ALKI ELEMENTARY SCHOOL DESIGN DEPARTURE RECOMMENDATIONS

Project #3039297-SD

February 1, 2023

Above Left: Roof Plan with highlighted Mechanical Penthouse, oriented east-west, as illustrated in the Departures Presentation dated August 2022

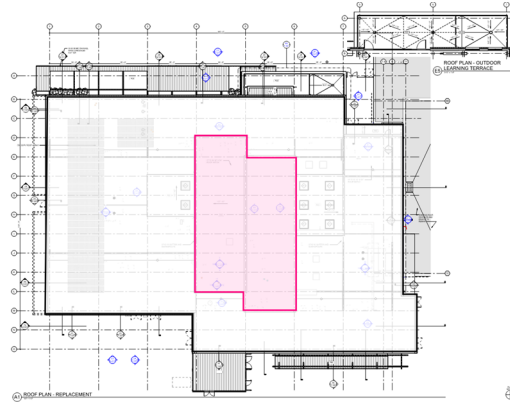
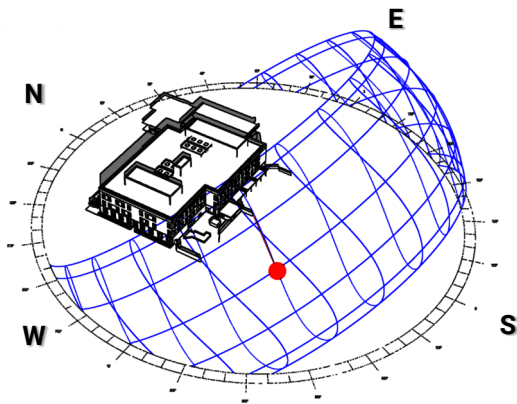
The height departure would result in rooftop mechanical system penthouses located much higher and closer to adjacent residences than in a building designed to conform to the land use code. Noise from this equipment will impact residents.

To address the views, shadowing, and noise, the project team noted that they had progressed in the design since the departure's presentation including updating the roof plan and rotating the mechanical penthouse away from the adjacent neighbors to the south. The project team noted that the building's interior lighting will be tied to occupancy sensors as required by the Seattle Energy Code; thus, lights will not be inadvertently left on to disturb neighboring residences after hours. Also, the completed shadowing study indicated shadowing from the building will fall primarily on the playfield and will not impact the residences to the south. In addition, the mechanical penthouse will be enclosed to increase longevity and reduce mechanical noise.

The proposed design calls for this Departure in order to meet the Seattle Public Schools' educational program specifications. A 500-seat school facility for the Alki Elementary School community accommodates potential growth, provides flexibility for changing program needs and demographics, and provides students with a safe and positive learning environment. SPS's planning approach balances the projected future regional and city growth with historical trends. The portions of the building that exceed the maximum height include the third floor of the main school building, the main school building roof parapet, and the mechanical penthouse, which is an enclosed room that protects equipment on the building roof. Enclosing the equipment increases longevity, reduces maintenance needs, allows for more energy-efficient equipment, and helps to reduce mechanical noise. The project team has progressed the design further since the Departure's presentation was completed a few months ago. As you can see from the updated roof plan on the following page, the long-side of the mechanical penthouse has been rotated away from the adjacent neighbors to the south.

Above Right: Updated Roof Plan with highlighted Mechanical Penthouse, oriented north-south, dated December 2022

Above: Site Plan Sketch illustrating reduced curb cut and curb cut flare widths

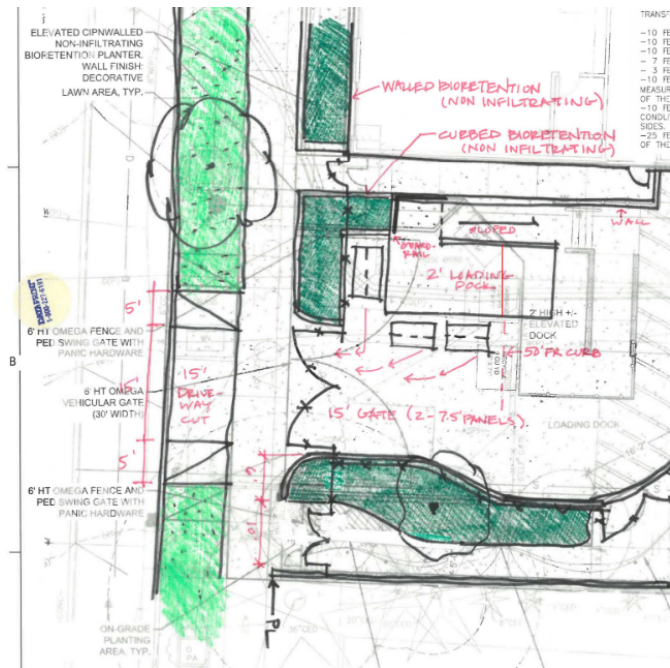
DON received few comments expressing concerns about the requested departure. Some of the comments expressed support for either granting or denying the departure without further explanation, while other comments noted that wider vehicular driveways conflict with pedestrian safety.

The stated rationale for the increased width does not make sense. The waste removal trucks drive forward into the site to the containers and are only on site for a few minutes. The delivery trucks will back in. Even if both types of truck are on site simultaneously, they can share the service area. Superimposing AutoTurn diagrams of typical waste removal and delivery truck turns will show that they can share a 30-foot-wide drive without conflict. It also is not true that a wider curb cut will improve sight lines for the driver. Sight lines will be identical.

There were a few people expressing concern about the requested Departure for Curb Cut and Curb Cut Flare Width, stating that wider vehicular driveways are in conflict with pedestrian safety. The proposal maintains that this driveway does not pose a risk to pedestrians because it would only be accessed by professional drivers for either waste collection or deliveries during non-active hours. We are actively working on a new plan with SDOT that would reduce the curb cut and/or flare widths per the preliminary sketch below. While it is our hope to not exceed the allowable widths, conversations are ongoing with SDOT and we request the Departure in order to give them and the team flexibility in finding a solution.

Massing model of existing community center and school, looking southeast from 59th Ave SW. Representative houses beyond on SW Admiral Way.

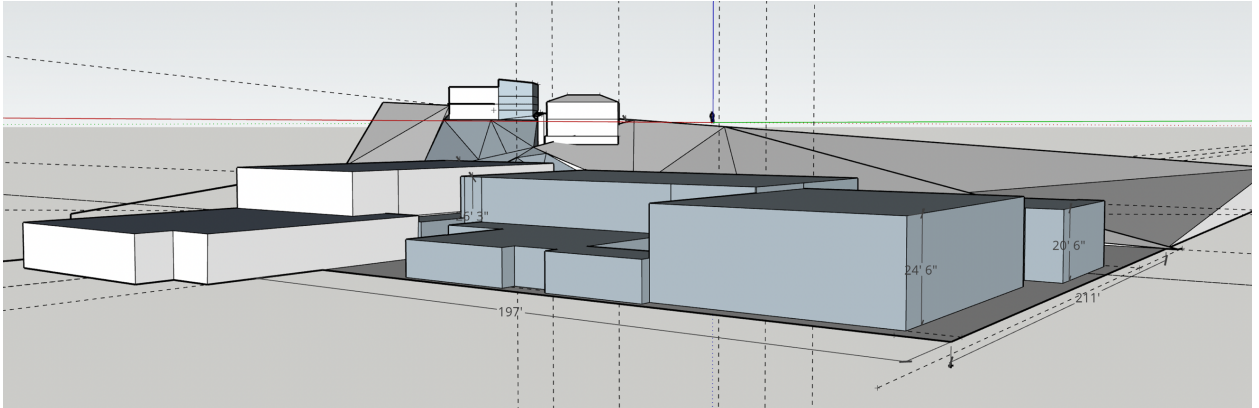
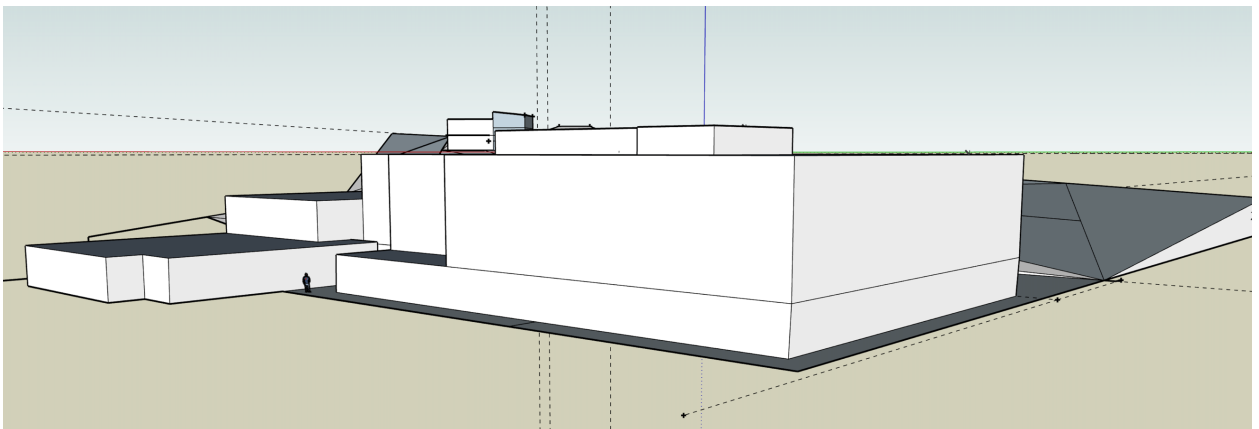
The proposed project requests a waiver from the normal 35-foot height limit allowed for public schools in a residential zone. The cited code paragraph states, “Height maximums in all residential zones may be waived by the Director as a Type I decision when the waiver would contribute to reduced demolition of residential structures.” Because the request does not demonstrate feasibility or need to demolish residential structures, the District’s request for increased height would instead require a Variance, a Type II decision.

Massing model of existing community center and school, looking southeast from 59th Ave SW. Representative houses beyond on SW Admiral Way.

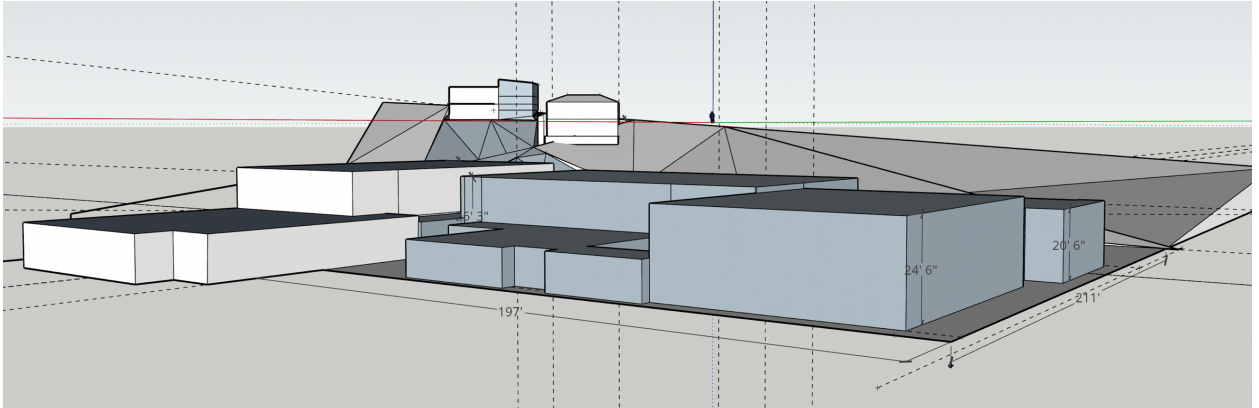
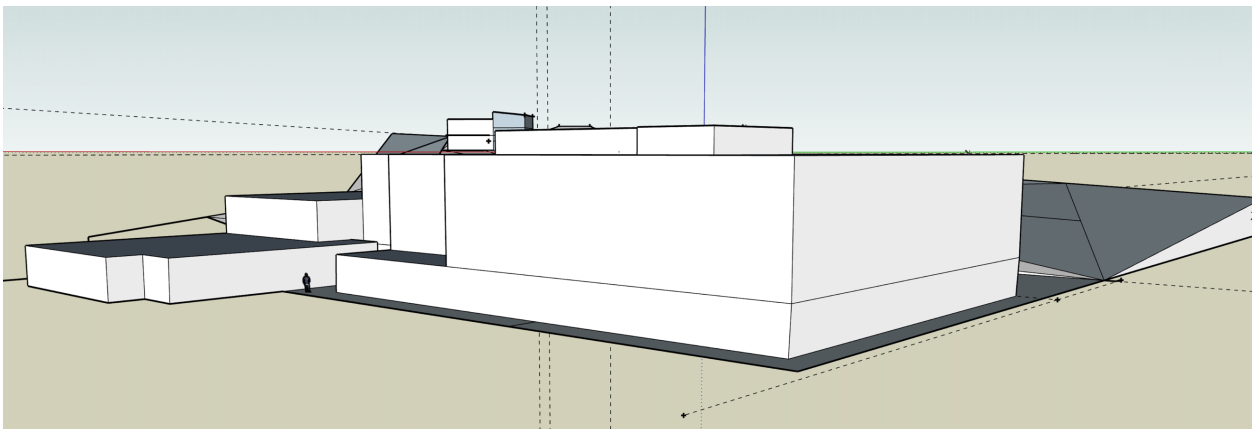
The proposed project requests a waiver from the normal 35-foot height limit allowed for public schools in a residential zone. The cited code paragraph states, “Height maximums in all residential zones may be waived by the Director as a Type I decision when the waiver would contribute to reduced demolition of residential structures.” Because the request does not demonstrate feasibility or need to demolish residential structures, the District’s request for increased height would instead require a Variance, a Type II decision.

The height departure would result in rooftop mechanical system penthouses located much higher and closer to adjacent residences than in a building designed to conform to the land use code. Noise from this equipment will impact residents.
